Carmichael Coal Mine

Advice on Groundwater Dependent Ecosystem Management Plan
v11b to the Queensland Department of Environment and Science

JUNE 2019

Figure 1. Fig 28 from Peeters et al (2018) showing the maximum modelled drawdown at three environmental assets (GAL_021, GAL_037, and GAL_043) for two alternate conceptualisations ("original" and alternate") of the Galilee Basin.

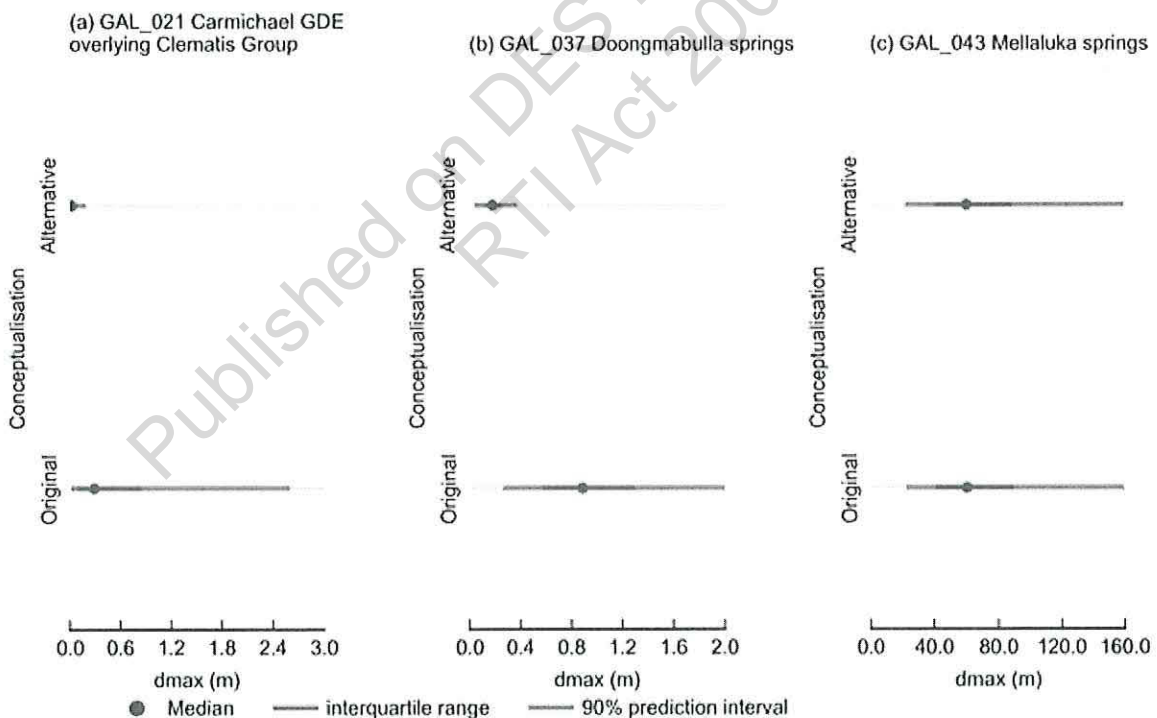
Recommendation: Attention should be equally spread across refining distributions of the most sensitive model parameters and efficient stochastic modelling (Turnadge et al., 2018).

Figure 2 Location of groundwater monitoring bores listed in Appendix B of GDEMP v11b and springs in the Doongmabulla Spring Complex (DSC), including Joshua Spring to the west of the proposed mine.

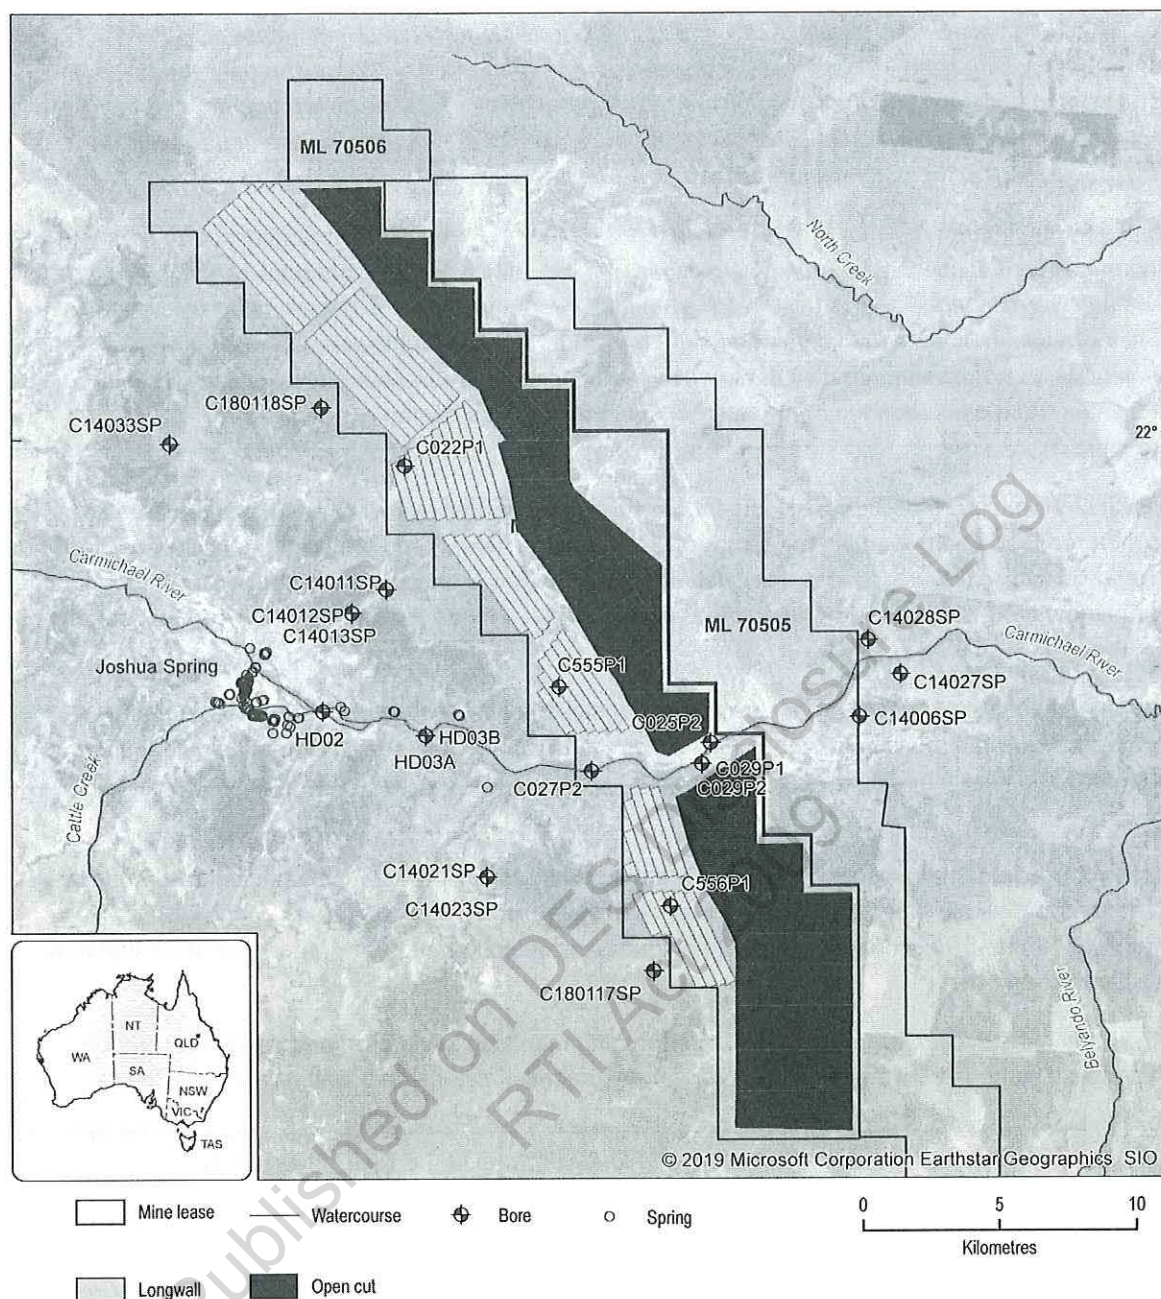
Issue: Groundwater drawdown trigger thresholds are not suitable for detecting drawdown rates in a timeframe that is comparable with routine monitoring data assessment and agreed groundwater model review periods.

CSIRO/GA advice to DoEE on the groundwater drawdown trigger thresholds recommends that “all monitoring locations for which water level thresholds are defined should also have drawdown rate limits derived. Evaluation of drawdown rate limits should form part of routine monitoring data assessment and be included in the Impact Threshold Assessment approach” (DoEE, 2019). The updated GMMP describes interim drawdown rate triggers (Table 46 of GMMP v8) for three bores (C022P1 – Dunda Beds, and C555P1, C556P1 – Rewan Formation, Figure 2) that specify predicted groundwater drawdown magnitude and rates over the next 0-2, 3-7, 8-12, 13-17 and 18-22 years.

Recommendation: Groundwater drawdown trigger thresholds should be set for all monitoring locations for which water level thresholds are defined, using a timeframe that is comparable with routine monitoring data assessment and agreed groundwater model review periods. Further, bore locations should consider localised changes that may impact on groundwater-dependent ecosystems and changes to groundwater conditions following planned longwall panel excavation beneath two of the three interim drawdown rate triggers bores. It is recommended that new groundwater drawdown trigger threshold bores are installed/identified as mining progresses.

Figure 3 Plot of predicted drawdown, early warning (low) and (high) impact thresholds for bore C022P1 – Dunda Beds from Appendix E of GMMPv7

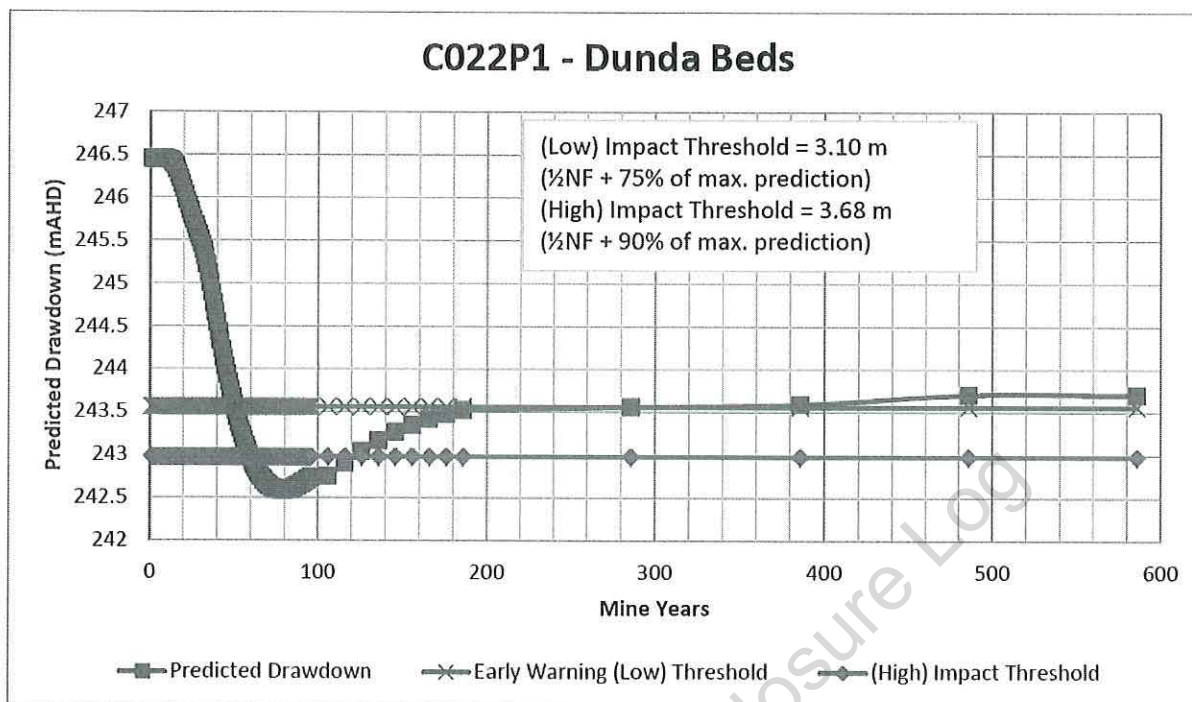
For bore C022P1 in the Dunda Beds, the interim drawdown rate trigger level is 0.48 m over the next 22 years, compared to the early warning trigger level (2.9 m after 50 years) and the (High) impact threshold (3.31 m after 60 years) (Figure 3). This demonstrates the importance of using a timeframe that is comparable with routine monitoring data assessment and the agreed review periods (2 years after the commencement of the box cut and then every 5 years).
